TECHNICAL BULLETIN

TRAILER AIR SUSPENSIONS SHOCK ABSORBER OPTION

No: TRAILER AUS -020
Subject: Shock Absorber Option
Date: JUNE 2002 **Revision:** A

Figure 1

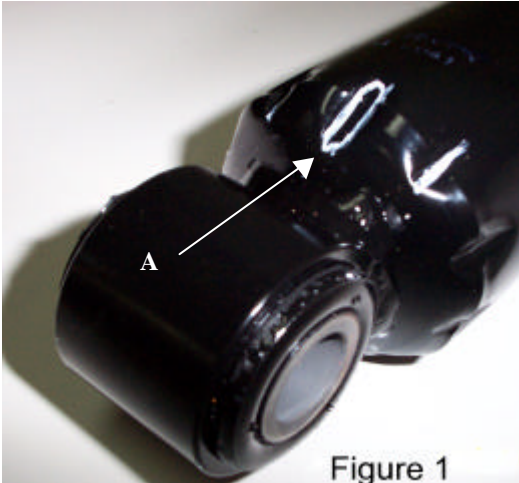
A large indentation (figure 1) [A] is pressed into to the end of the shock absorber body. When the shock absorber is installed, this indentation **MUST** be facing upwards.

Figure 2

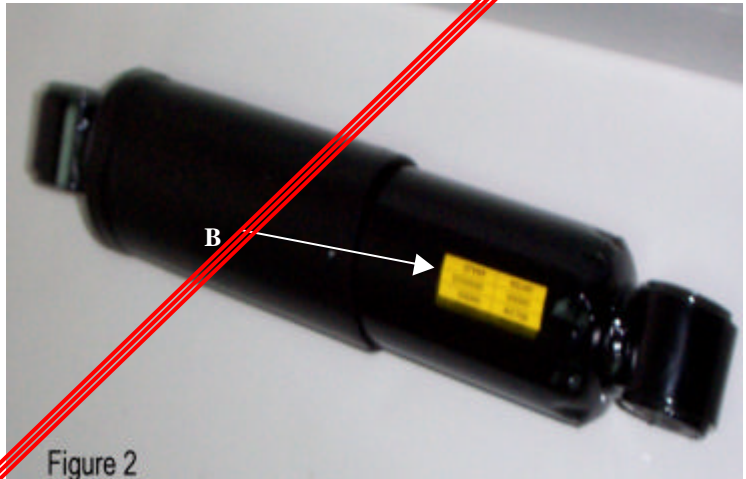
In addition to this, a Yellow sticker (Figure 2) [B] indicates that this side of the shock absorber faces downwards.
